## **Blackstone Boulevard Path Improvements**

### **Addendum # 1**

**October 15, 2021**

**EXISTING CONDITIONS/DEMO PLAN 1**  
**BLACKSTONE BLVD PATH IMPROVEMENTS PROJECT**  
**240-350 BLACKSTONE BOULEVARD**  
FILE: BLACKSTONE\_BLDV\_PATH\_EX.DWG

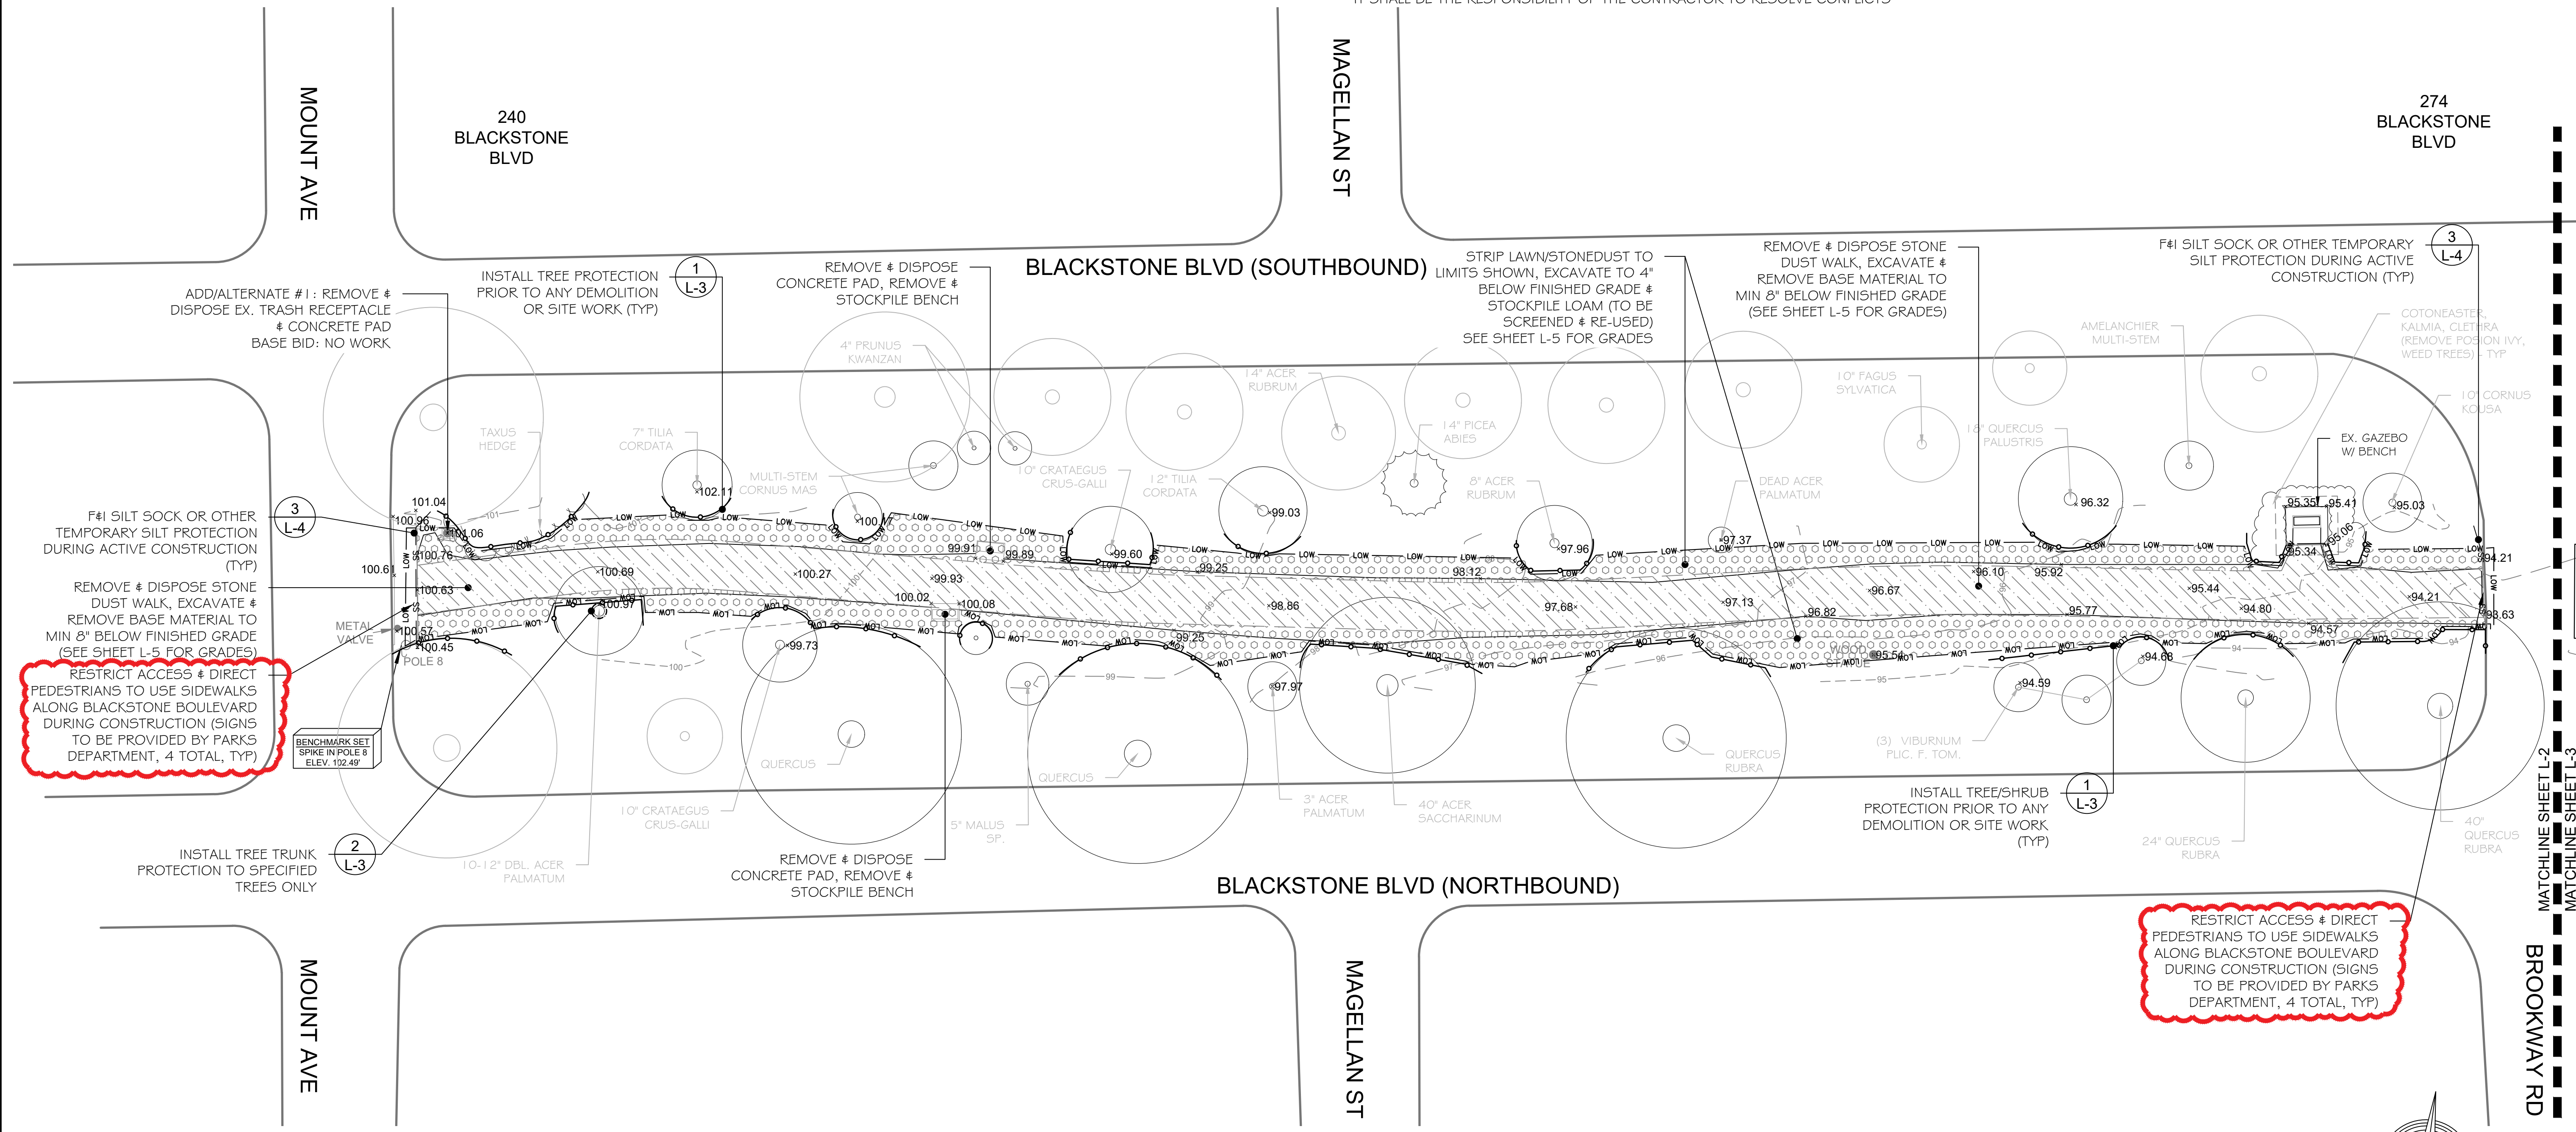
- ❖ How should pedestrian traffic be directed during construction?
  - Pedestrians will be directed to use the sidewalks on either side of Blackstone Boulevard between Mount Ave & Rochambeau. Construction fence and a sign (provided by Parks Dept) should be attached at path ends (4 in total).
  - See Attachment 3 - revised plans.
- ❖ Specification 32500 – Erosion & Sedimentation Controls is missing
  - See Attachment 4

NO.	REVISION	DATE
1	Pedestrian Direction/Jute	10.15.21

RESTRICT ACCESS & DIRECT PEDESTRIANS TO USE SIDEWALKS ALONG BLACKSTONE BOULEVARD DURING CONSTRUCTION (SIGNS TO BE PROVIDED BY PARKS DEPARTMENT, 4 TOTAL, TYP)

RESTRICT ACCESS & DIRECT PEDESTRIANS TO USE SIDEWALKS ALONG BLACKSTONE BOULEVARD DURING CONSTRUCTION (SIGNS TO BE PROVIDED BY PARKS DEPARTMENT, 4 TOTAL, TYP)

# GRADING PLAN 1

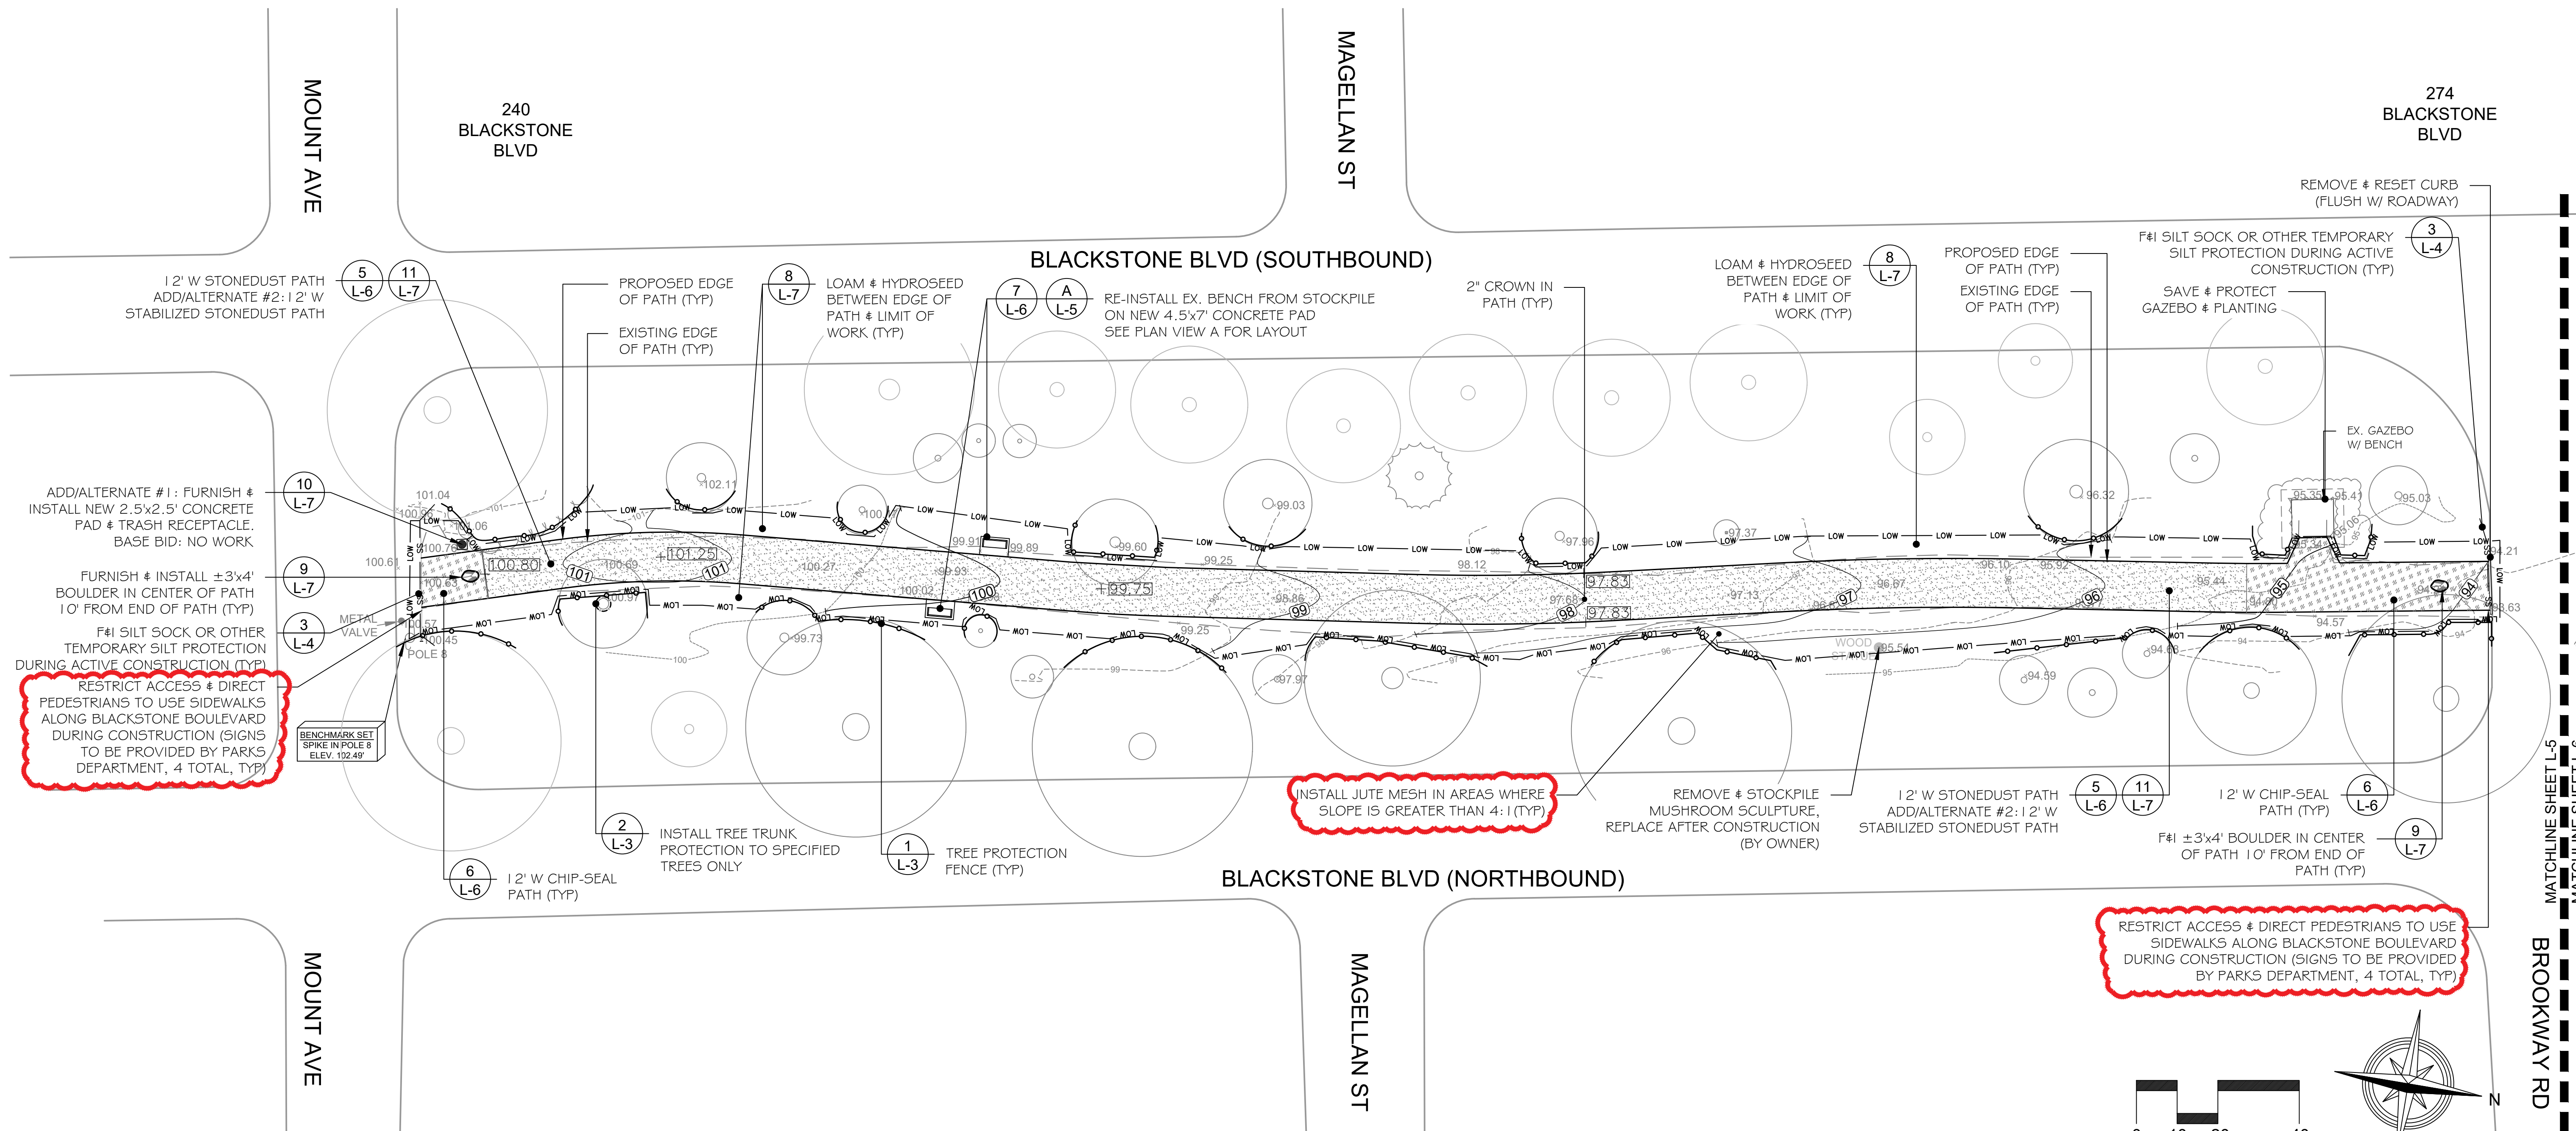
- ❖ Unit Price Item #14 is for Jute Mesh in locations greater than 3:1, but it is not in the drawings or specifications, is it still included in the project?
  - This item should read as greater than 4:1. There are a few locations that have slopes greater than 4:1 slope. A note has been added to the drawing and Jute Mesh is included in the attached Spec Section. See Attachment #5

NO.	REVISION	DATE
1	Pedestrian Direction/Jute	10.15.21
